In the matter of the direct referral of applications for resource consent and notices of requirement under sections 87G and 198E of the Act for the Ōtaki to North of Levin Project

**STATEMENT OF REBUTTAL EVIDENCE OF ANDREW ROBERT CRAIG ON
BEHALF OF WAKA KOTAHI NZ TRANSPORT AGENCY**

Dated 10 October 2023

Figure 1: Prouse property 1:100 AEP flood event with climate change (top image original results, bottom image with additional culverts)

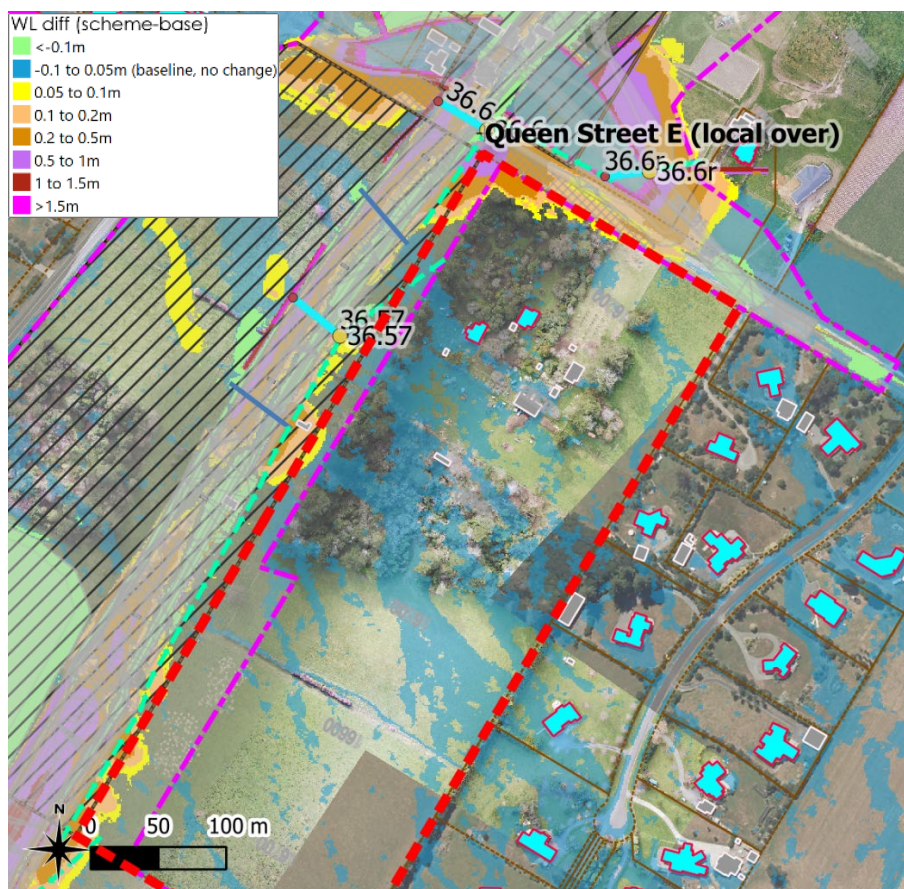
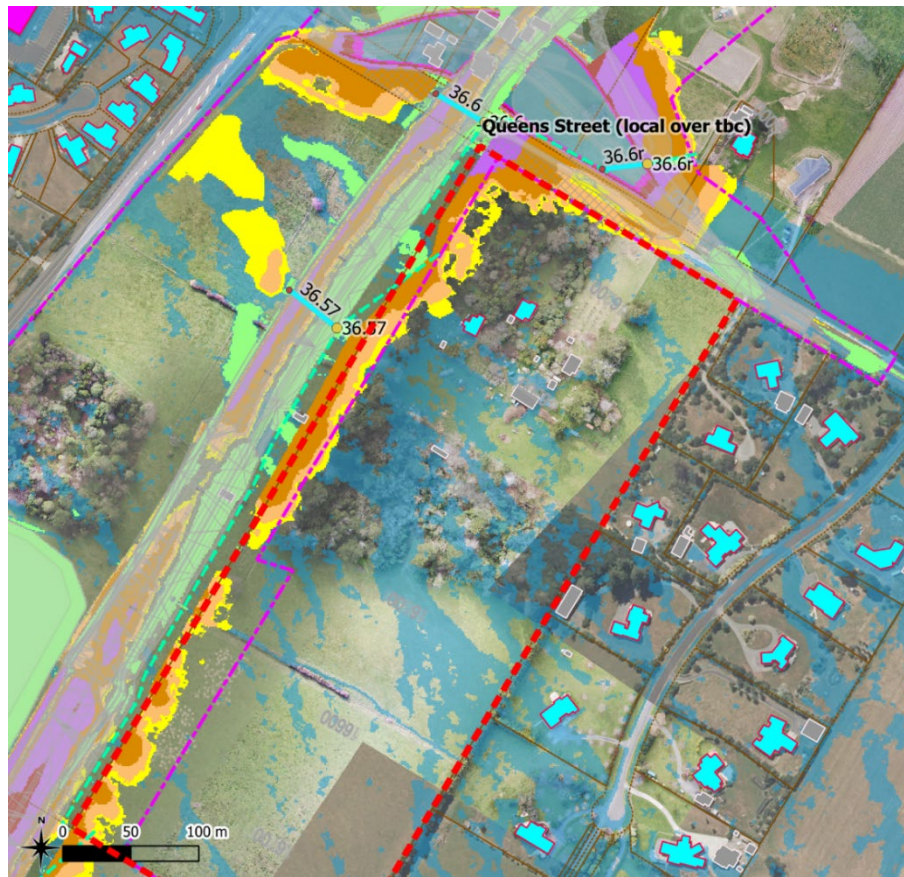
13. Since the production of the concept design drawings and Technical Assessment F, I have tested the potential for refinements to the design to reduce the extent of flooding on the Prouse property at 1024 Queen Street East, to explore how detailed design may suitably address flooding effects. This includes consideration of that portion proposed to be leased for construction that will later be returned to the Prouse estate.
14. Additional culverts were added to the model, with their locations based on natural concentrations of overland flow observed in the baseline model (without Ō2NL Project).
15. The ‘bund’ that separates overland flows from the highway swales has been moved closer to the highway and integrated with the Shared Use Path (**SUP**) (i.e., the SUP sits on top of the bund). This is the logical design arrangement

16. The revised modelling shown below indicates that a substantial reduction in flood levels can be achieved for the 1:100 AEP flood event with climate change, when compared to the original concept results in Technical Assessment F. There are some design details such as the size and form of stilling basins and/or inlet trash screens that are not yet optimised. Whilst the design will be refined further through detailed design, this modelling indicates the sort of performance that is likely to be achieved.
17. Reasonable endeavours will be made by Waka Kotahi designers to further minimise any increases in flood level. The conditions proposed and attached to Ms McLeod's evidence include wording to ensure detailed design continues to lessen flooding effects as far as reasonably practicable.

18. Statements made by Mr Kinley referenced by Mrs Prouse (paragraph 31), and Ms Carter (paragraphs 62-65) were made by Mr Kinley before the more recent assessment with additional culverts. I therefore regard the references to Mr Kinley's statements as superseded by the modelling results shown above.

19. Ms Carter seems to have incorrectly interpreted my flood mapping outputs in her paragraph 20(g) where she suggests baseline depths on the property "between 0.01m (10mm) and 0.05m (50mm)". Baseline model depths exceed 0.2m in places along both the designation boundary and the property boundary. The blue colour shown on the 'difference' images labelled '-0.1 to 0.05m (baseline, no change)' are showing those areas that are already wet (>0.05m) in the baseline model, and where the difference between with and without project is within this narrow band from -0.1m to +0.05m (to account for model tolerance), reflecting no change from the status quo. This does not imply that the baseline depths are -0.1m to +0.05m.

Figure 2: Northern corner of the Prouse property (looking south) where greatest increase in flood level occurs

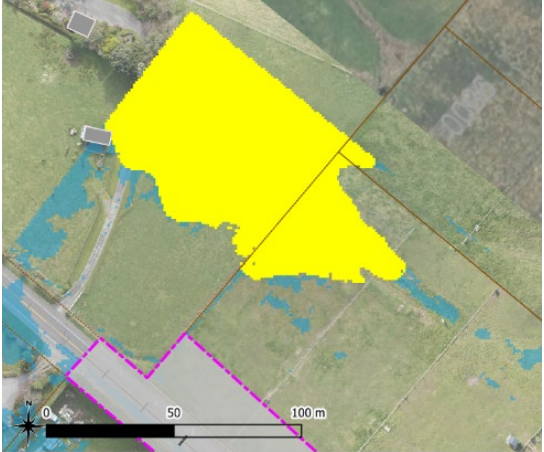
20. The modelled water level increase at the northern corner of the Prouse property (shown in the Figure 2 below) for the 1:200 AEP current climate (the event magnitude referenced in the One Plan) is 0.2m with the additional culverts in place. Any other locations of increased flood level along the property boundary will be less than this magnitude.

21. Given the existing pastoral land use shown in the photo, and its occasional use as an accessway to the rear paddock², I consider the land use would be reasonably tolerant to slight, localised and short duration increases in flood

levels during rare flood events. Therefore, I consider this effect less than minor from the perspective of hydrology and flooding.

22. As indicated in my summary, I do not support a condition as indicated by Mrs Prouse³ constraining effects to less than 50mm increase in flood level which could result in other perverse outcomes or effects in order to avoid this less than minor effect.
